FDI	ENGINEERING CHANGE ORDER		ECO NO: 09-005b
			Page 1 of 2
TITLE	DWG NO.	CURRENT REV	NEW REV
ARM9DIMM LP3250	ARM9DIMM	1.0	1.1

FDI	ENGINEERING CHANGE ORDER		ECO NO: 09-010
			Page 1 of 1
TITLE	DWG NO.	CURRENT REV	NEW REV
ARM9DIMM LP3250	ARM9DIMM	1.1	1.2

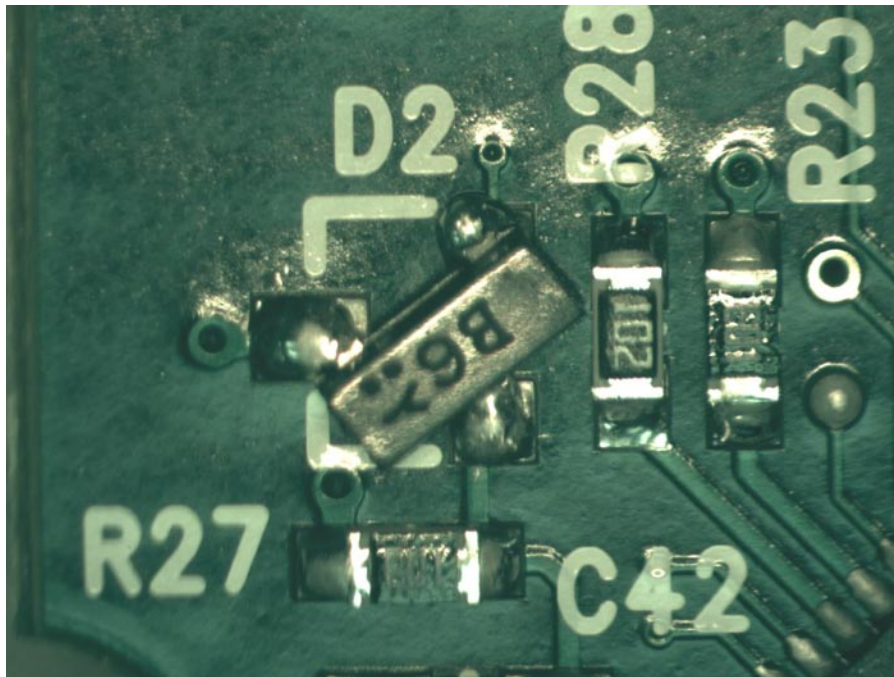
- The Ethernet PHY is intermittent and would powerup at different addresses. It was determined that the reset circuit was not functioning properly due to improper footprint for D2.
- The CPU core voltage needs to be increased to 1.35V in order to support 266MHz.
- The Wall Power Detect needs to be disconnected from the LPC3250 to allow the touch screen to function properly.
- The Seggar JTAG Debugger utilizes a IDC 10-pin 2mm ribbon connector that will not work with the original shrouded connector
- The Debug Connector is required for initial programming

1. Rotate D2 diode 120 degrees counter-clockwise

2. Change the following resistor values:
 - a. Change R119 from 5.49K, 1% to 3.65K, 1%, 0603
 - b. Change R120 from 10.0K, 1% to 4.99K, 1%, 0603
 - c. Change R122 from 24.0K, 1% to 17.4K, 1%, 0603

Reason for change: <ol style="list-style-type: none"> 1. Correction of SOT23 footprint 2. Vcore increase to 1.35V 3. Isolate Wall Detect from TS AD input 4. Change to un-shoruded connector for Seggar JTAG 5. Load J1, FDI PN: J500030 		Disposition/Effectively	
		Use as is	
		Rework to ECO	X
		Scrap & Rebuild	
		Record Change Only	
Prepared by:	M. Hall	Date:	05/08/09
Approved by:		Date:	
Approved by:		Date:	
Approved by:		Date:

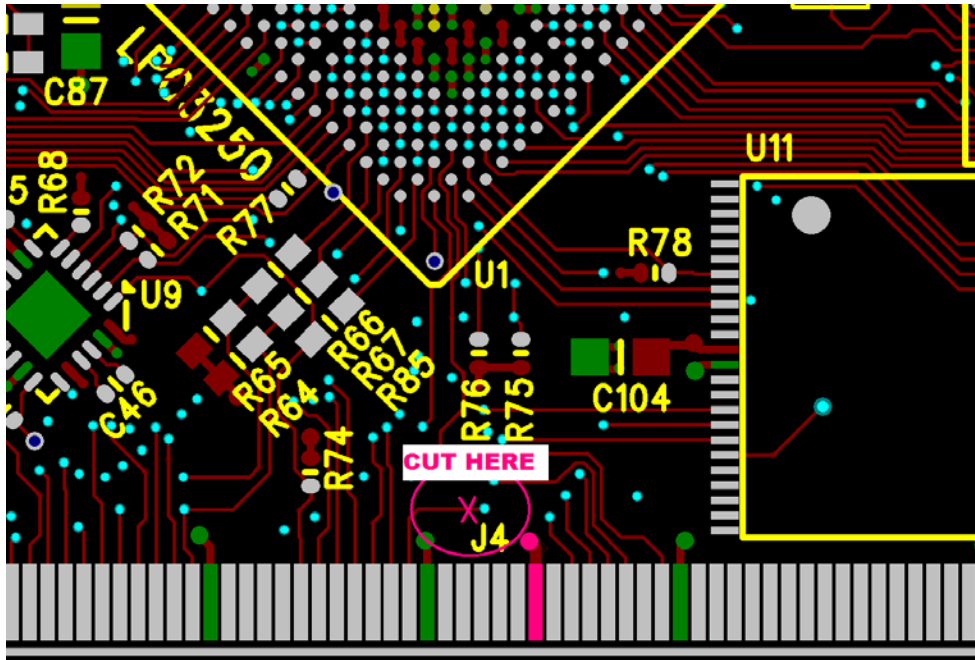
3. On the top side, cut the trace

4. Change J3 from Hirose DF11 shrouded connector (J000168) to Norcomp 2mm un-shrouded right-angle 2mm 5x2 header, FDI PN: J100036
5. Change J1 to "LOAD", FDI PN: J500030 , Qty = 1

Reason for change: <ol style="list-style-type: none"> 1. Correction of SOT23 footprint 2. Vcore increase to 1.35V 3. Isolate Wall Detect from TS AD input 4. Change to un-shoruded connector for Seggar JTAG 5. Load J1, FDI PN: J500030 		Disposition/Effectively	
		Use as is	
		Rework to ECO	X
		Scrap & Rebuild	
		Record Change Only	
Prepared by:	M. Hall	Date:	05/08/09
Approved by:		Date:	
Approved by:		Date:	
Approved by:		Date:
